CONT No 80-34  
WP No 134-74-01  
BAY OF QUINTE CROSSING  
PRELIMINARY INVESTIGATION  
BORE HOLE LOCATIONS & SOIL STRATA

Re: The Norris Whitney Bridge (Bay of Quinte)  
W.P. 134-74-01, Contract 80-34, Hwy. 14

## MINUTES OF DESIGN PACKAGE REVIEW MEETING

Re: Bay of Quinte Crossing  
at Belleville  
W.P. 134-74-01, Site 28-28  
Hwy. 14, District 8, Kingston

SHEET 10

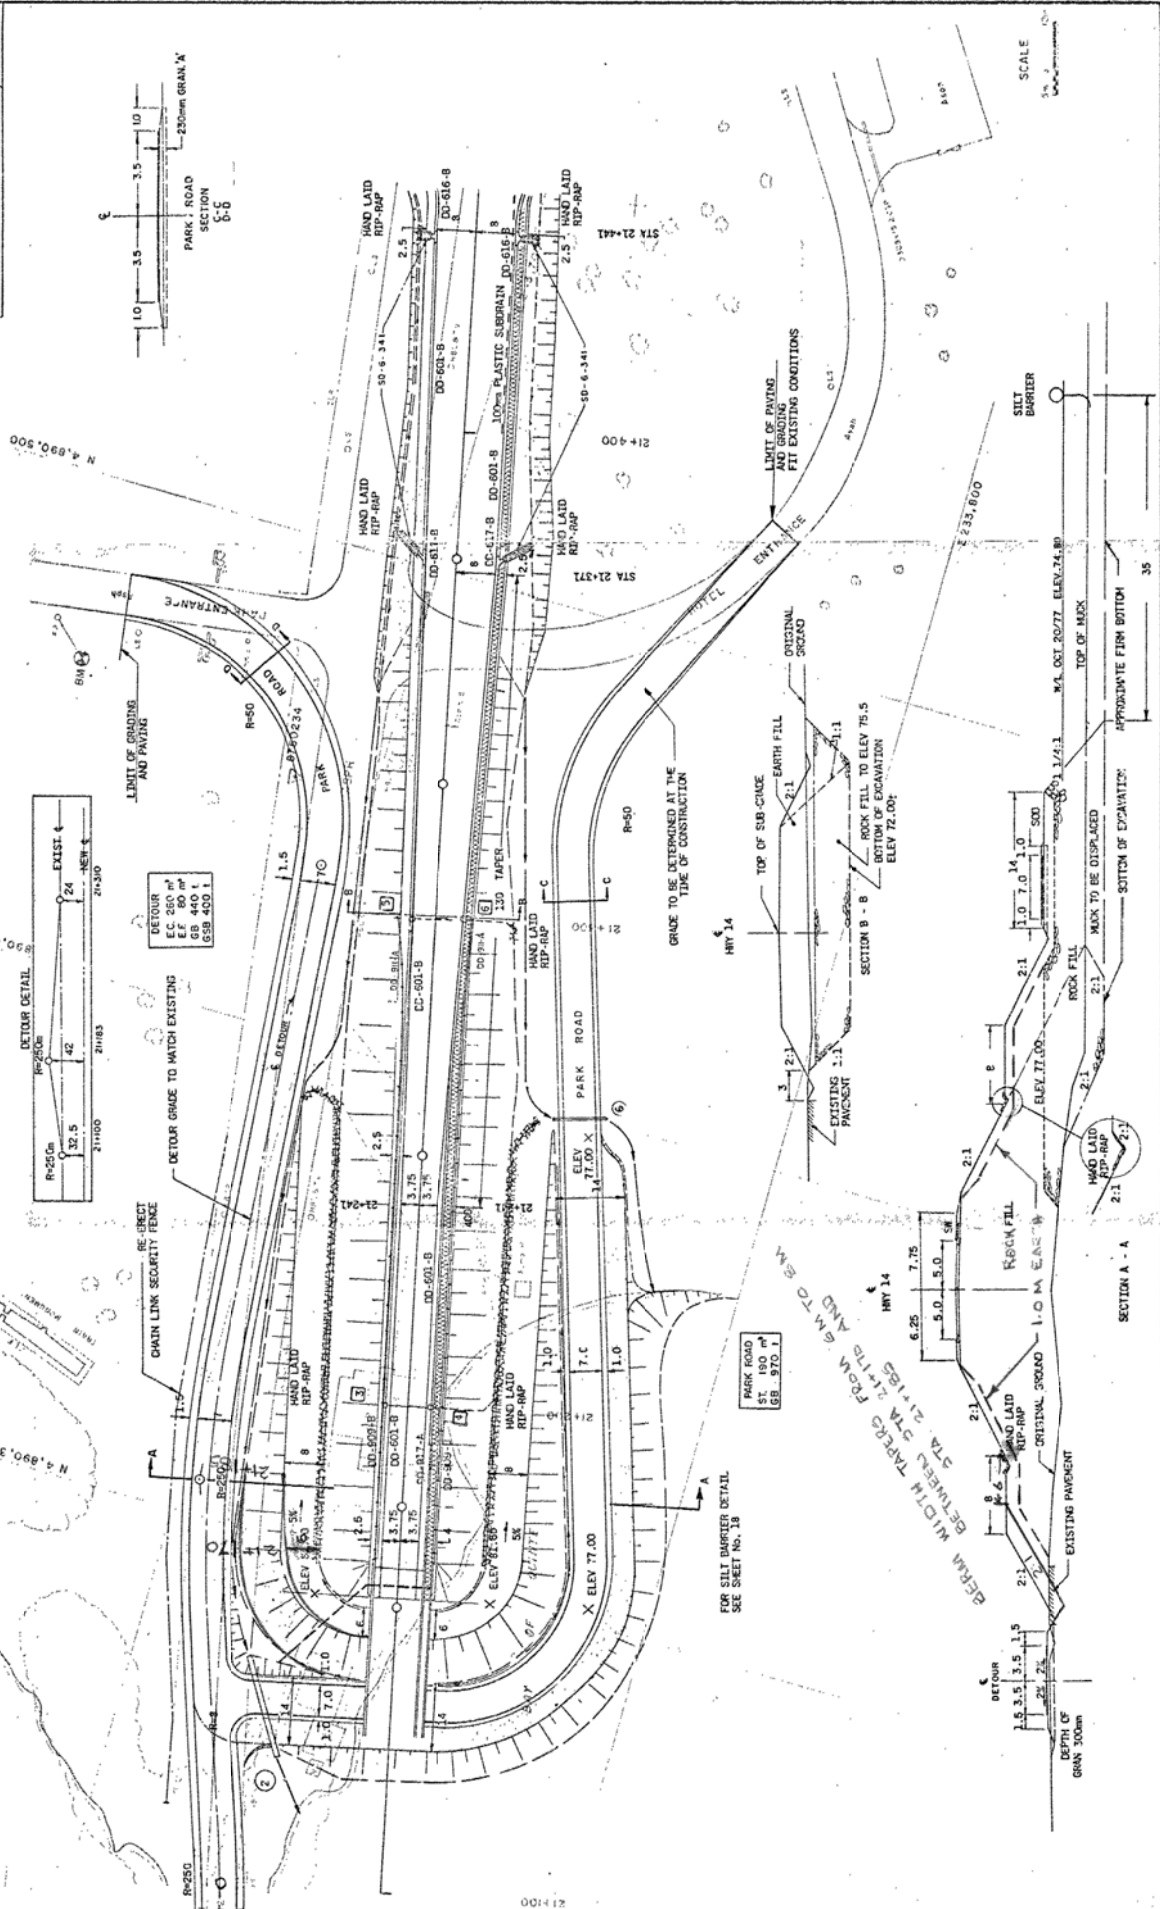
Further to our telephone conversation on Thursday, November 13th, we enclose a sketch showing proposed modifications to the upper berm of the north approach. Considering the fact that there must be a sufficient depth of earth on the approach to support tree and shrub growth, the side slope should be constructed at a 2:1 slope rather than at the  $1\frac{1}{2}$ :1 slope recommended by the Construction Office.

Due to restricted area on the left side at Stations 21+160 and 21+175 the theoretical cross-section as shown on Sheet #10 requires revision.

1. Replace Culvert 2 with 600 mm CSP instead of 900 mm.
2. Place 20 m of 600 mm CSP under new entrance to West Zwick's Park.
3. Because of 1 and 2 above the drainage pattern will be split at Station 21+360.
4. Because of 1, 2 and 3 the low invert of culvert can be raised .3 m and the ditch to the north by corresponding depths.
5. Steepening of Berm side slopes Station 21+160 and 21+175 to  $1\frac{1}{2}:1$  are still a requirement.

Further to your recent memo, we have reviewed the revised geometry incorporating a modified upper berm width ranging from 6 m to 8 m between Sta. 21+170 and Sta. 21+185 for the north approach. This memo confirms our telephone conversation with you indicating that the proposed modification will be satisfactory from the stability point of view.
